Amendment A-11

2015 International Residential Code

International Residential Code®, 2015 Edition (IRC®, 2015)

The following sections, paragraphs, and sentences of the *2015 International Residential Code* are hereby amended as follows: Standard type is text from the IRC. Underlined type is text inserted. ~~Lined through type is deleted text from IRC.~~

Figure R602.6.1; delete the figure and insert the following figure:

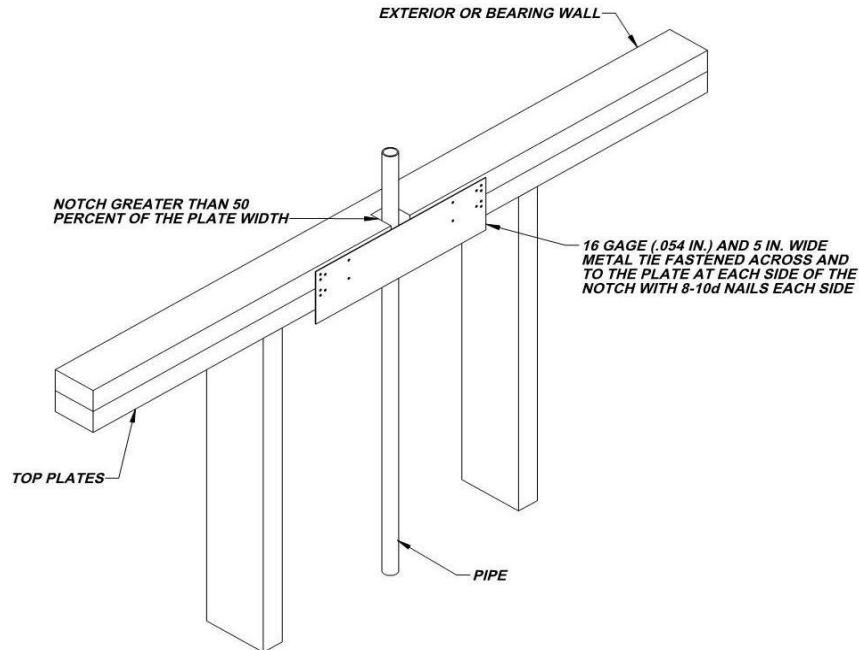
R602.6.1 Drilling and notching of top plate. When piping or ductwork is placed in or partly in an exterior wall or interior load-bearing wall, necessitating cutting, drilling or notching of the top plate by more than 50 percent of its width, a galvanized metal tie not less than 0.054 inch thick (1.37 mm) (16 Ga) and ~~1½ inches (38) mm~~ 5 inches (127 mm) wide shall be fastened across and to the plate at each side of the opening with not less than eight 10d (0.148 inch diameter) having a minimum length of 1 ½ inches (38 mm) at each side or equivalent. Fasteners will be offset to prevent splitting of the top plate material. The metal tie must extend a minimum of 6 inches past the opening. See figure R602.6.1. {remainder unchanged}
